FINDING OF NO SIGNIFICANT IMPACT 4 (f)

Interstate Route 270

From Y-Split to Maryland Route 121

FEDERAL HIGHWAY ADMINISTRATION
FINDING OF NO SIGNIFICANT IMPACT
FOR
INTERSTATE 270 WIDENING PROJECT
FROM Y-SPLIT TO MARYLAND ROUTE 121
MONTGOMERY COUNTY, MARYLAND

PLAN - BUILD ALTERNATE
STA. 170+00 - 193+00

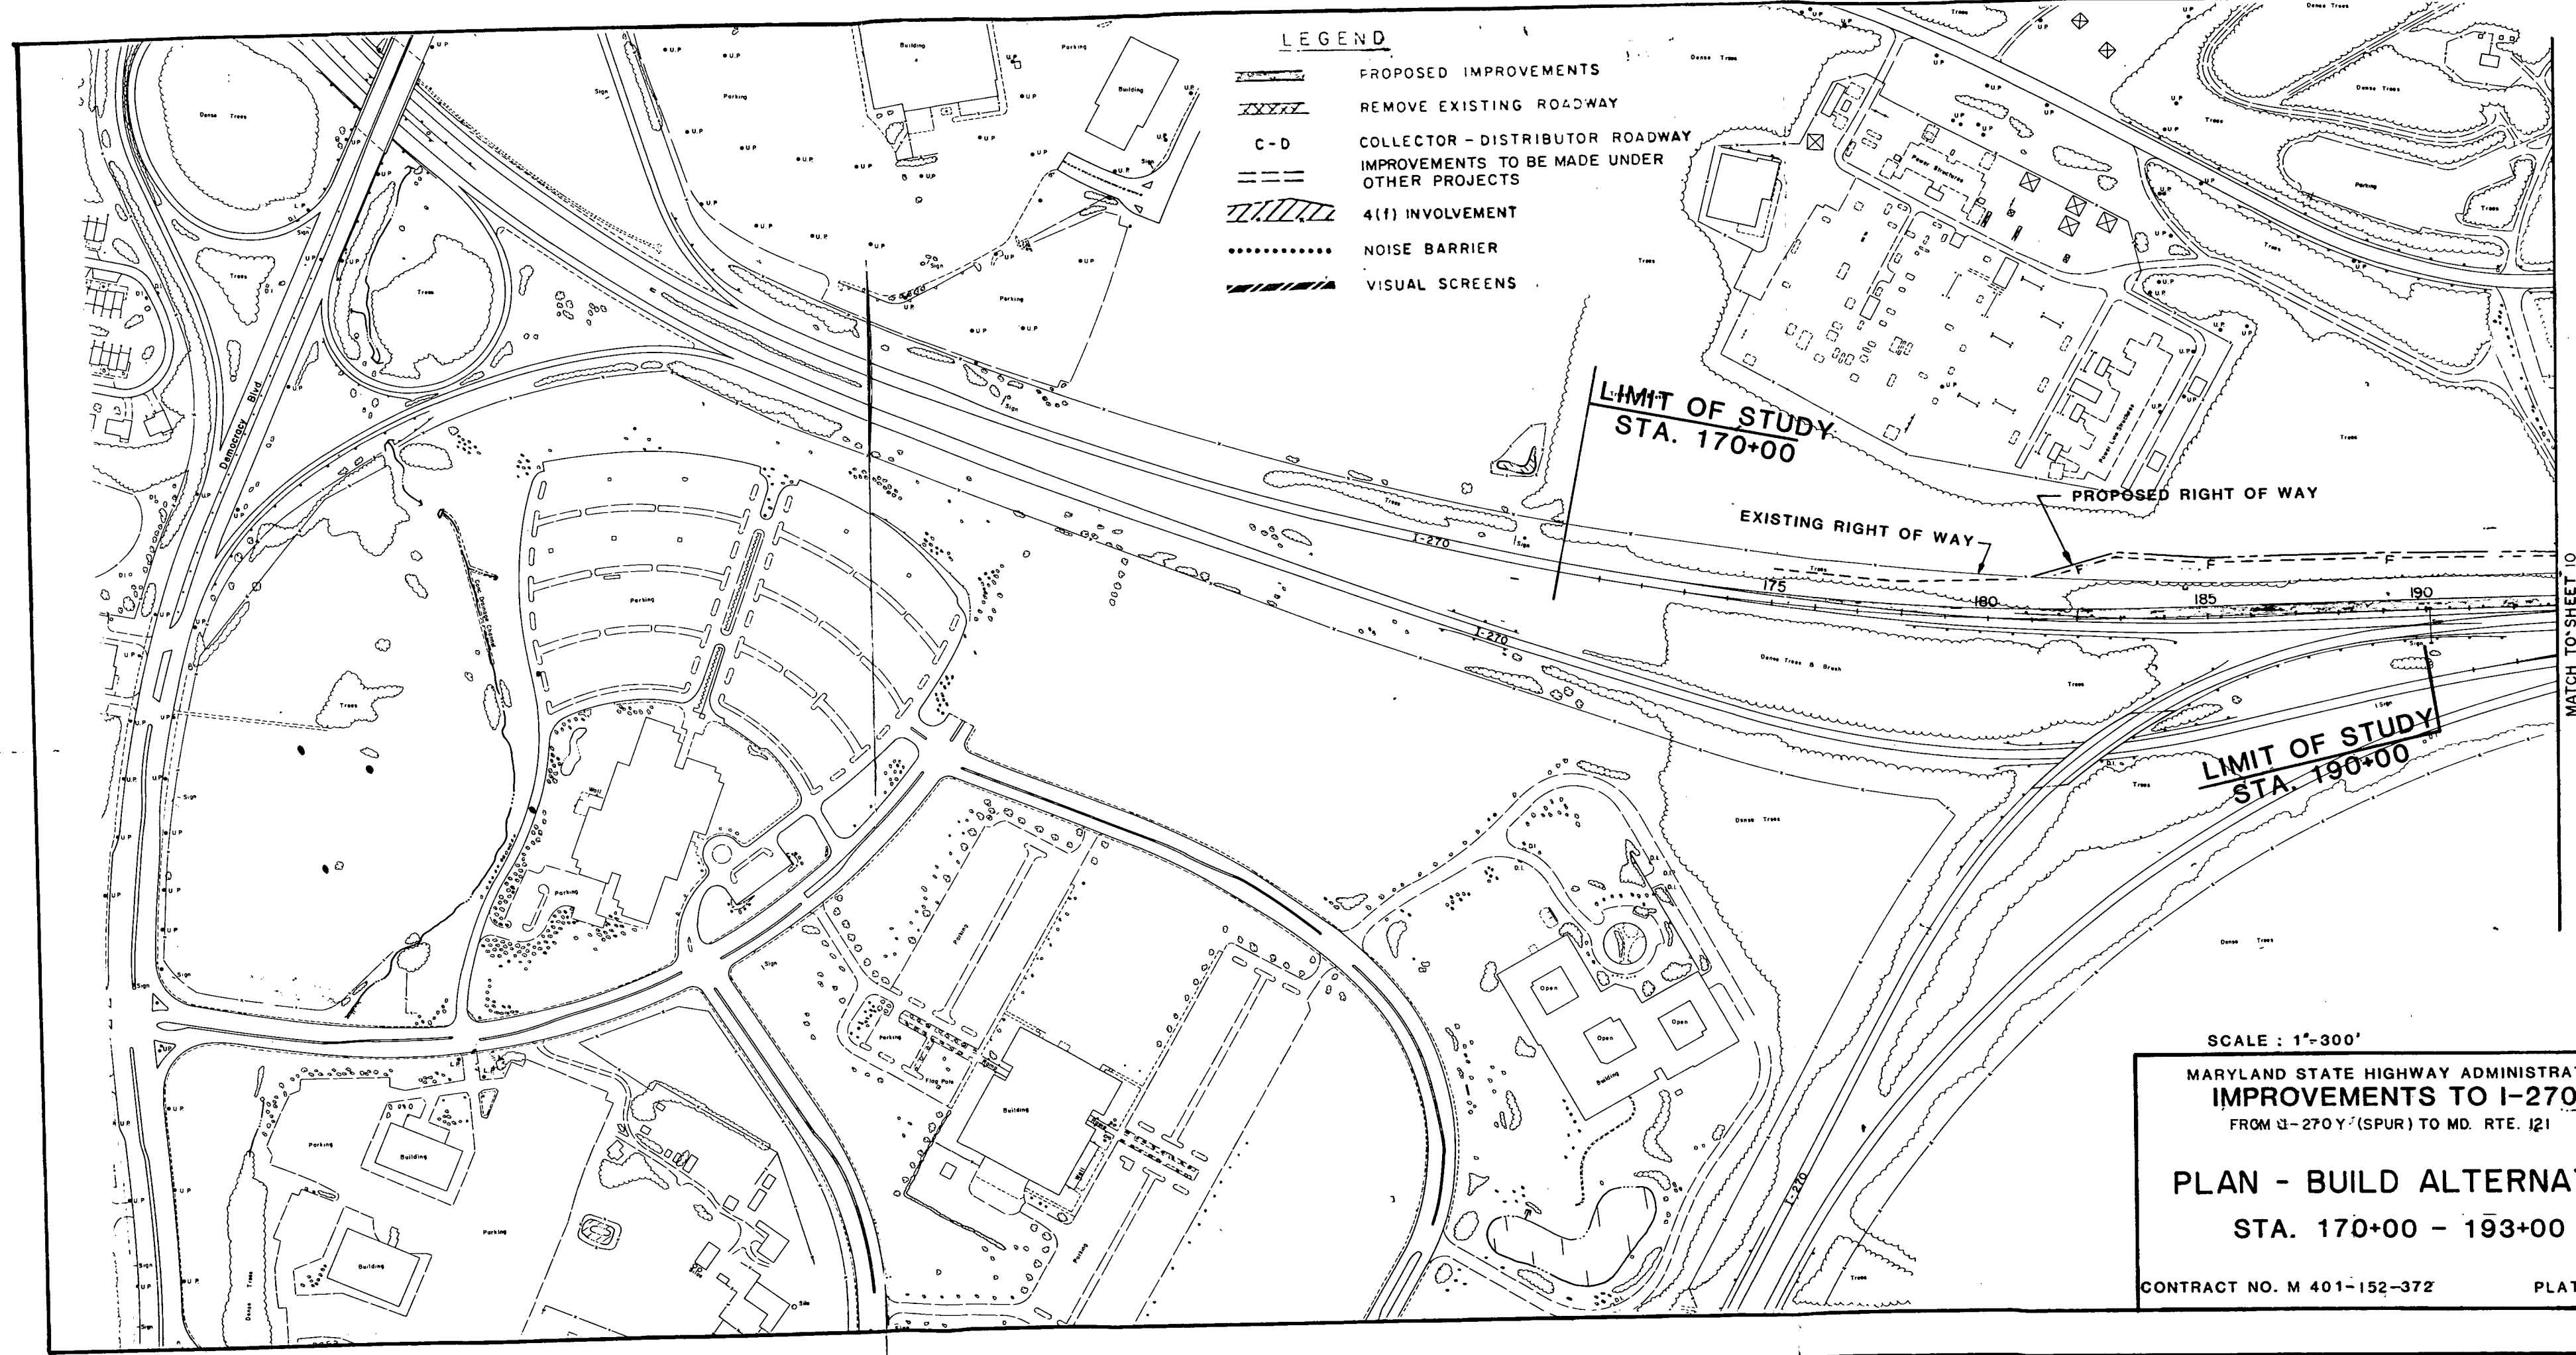
Since the Public Hearing, and at the recommendation of Maryland National Capital Park and Planning Commission, the agency having jurisdiction over the park, a shift of the roadway 24 feet to the west has been adopted to reduce the impacts on the residences on the east side of I-270 south of Montrose Road. This shift slightly increases the potential encroachment onto the park for grading.

Discussions with the Maryland National Capital Park and Planning Commission (MNCPPC) were held to determine mitigation measures to be adopted. In the areas of cut, it was decided that 8 foot retaining walls would be provided from Sta. 208+00 to Sta. 215+50 and from Sta. 227+25 to Sta. 237+00 to reduce the cut slopes in the park. The fill slopes would be allowed to fall onto the park and the MNCPPC would grant temporary construction easements for any grading required within the park. Landscaping and revegetation of the slopes would be performed to the satisfaction of the MNCPPC. This treatment was considered more prudent by MNCPPC than avoidance by retaining wall in that it provided a more natural and aesthetically acceptable treatment of the landscape. A total of 7.8 acres of temporary construction easements will be required. The area will be returned to MNCPPC for park purposes and remain under the jurisdiction of MNCPPC after construction is completed.
